OFFICIAL NOTICE NO. 155

**ADDENDUM NO. 1**

Century City Redevelopment Project  
3533 North 27<sup>th</sup> Street  
Milwaukee, Wisconsin

CENTURY CITY  
REDEVELOPMENT  
PROJECT AREAS A,  
B AND C  
ASBESTOS AND  
HAZARDOUS  
MATERIALS  
INSPECTION  
SERVICES

AREA B - BLDGS  
64 & 85

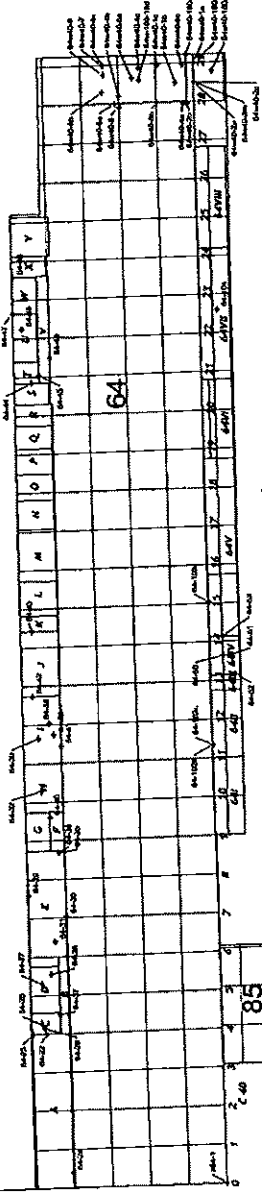
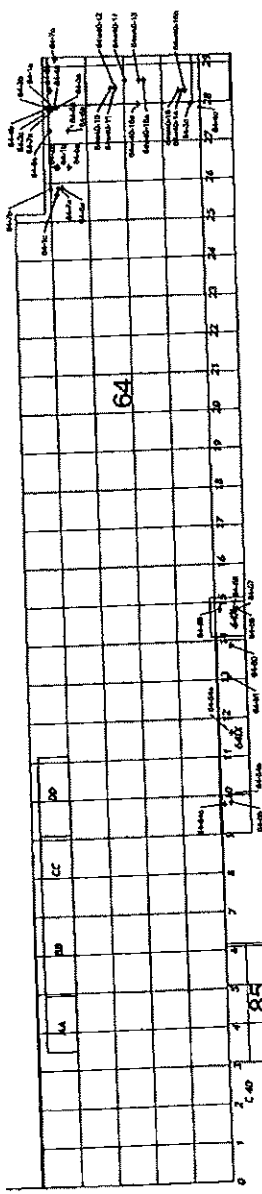
- Q. For Building 64W40 – the asbestos survey Appendix A – Table 1 Summary of ACM references building 69 (NO ACM) but the summary of ACM indicates Pipe TSI, Electrical Fuse/Switch Box Insulations, Duct Wrap, and Black Mastic. Could you please provide a revised section of the survey to reflect the amount of quantities to be removed?
- A. A corrected version is attached.

ARBA-B-BLDS  
60 & 58

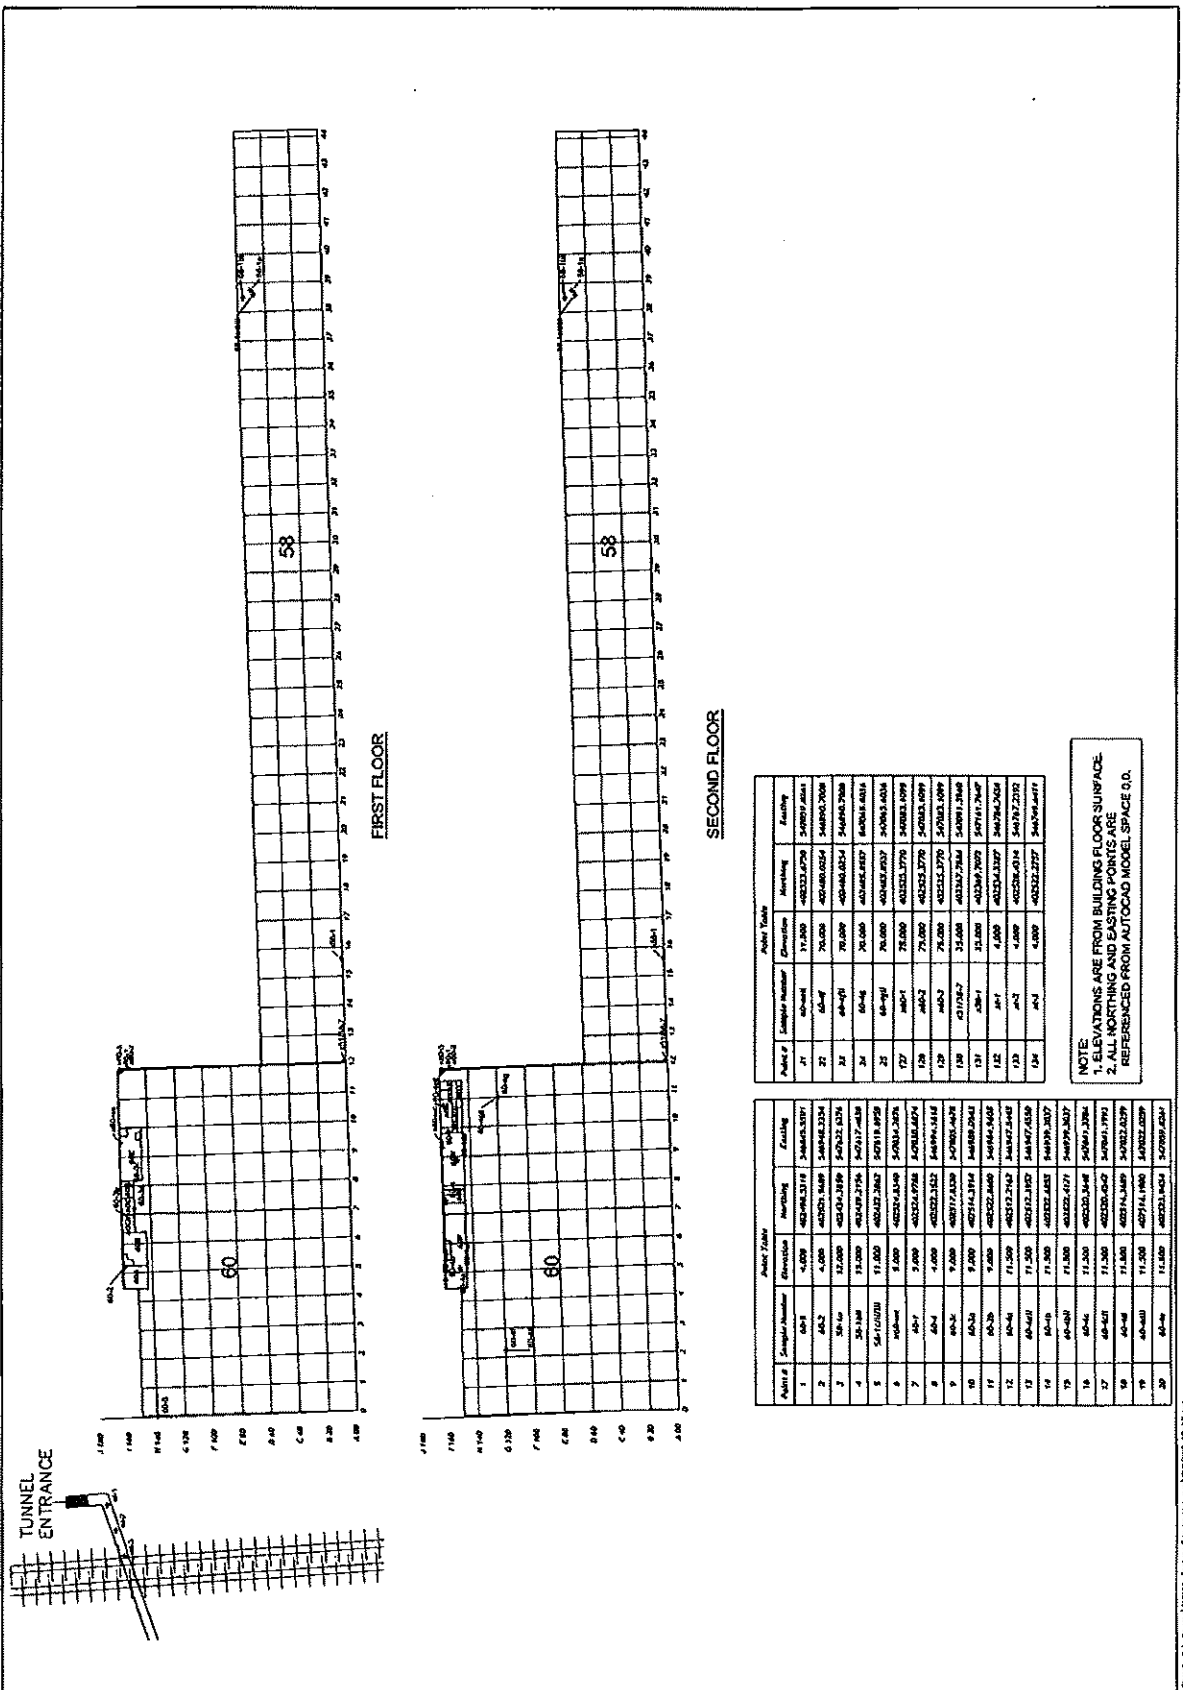
Q. Building 58 references building 85 throughout the report. Could you provide a clarification or a revised report for building 58?

A. The revised Building 58 report is attached to this addendum.
